This Service Information bulletin supersedes SI B64 04 12 **dated September 2013.**

Blower Makes an Unusual Noise

F30 (3 Series Sedan)

64 11 213 Removing and installing/replacing heating and air conditioning blower

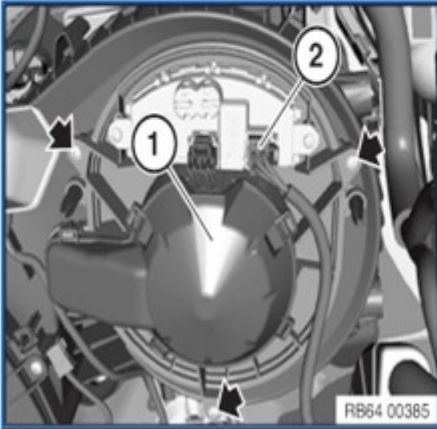
Unlock plug connections (2) and disconnect.

Release screws at marked points.

Remove blower (1).

Hold blower (1) in installation position and tighten all screws evenly.

- If debris or foreign material was found in the blower motor and housing, install a revised screen and coarse filter.

- If the vehicle already has the previous “basket screen kit” installed:
 - Remove the early basket and foam strips.
 - Install the new repair kit 64 31 9 321 616.
- If the vehicle has no filter screen installed:
 - Install the new honeycomb screen repair kit 64 31 9 321 616.
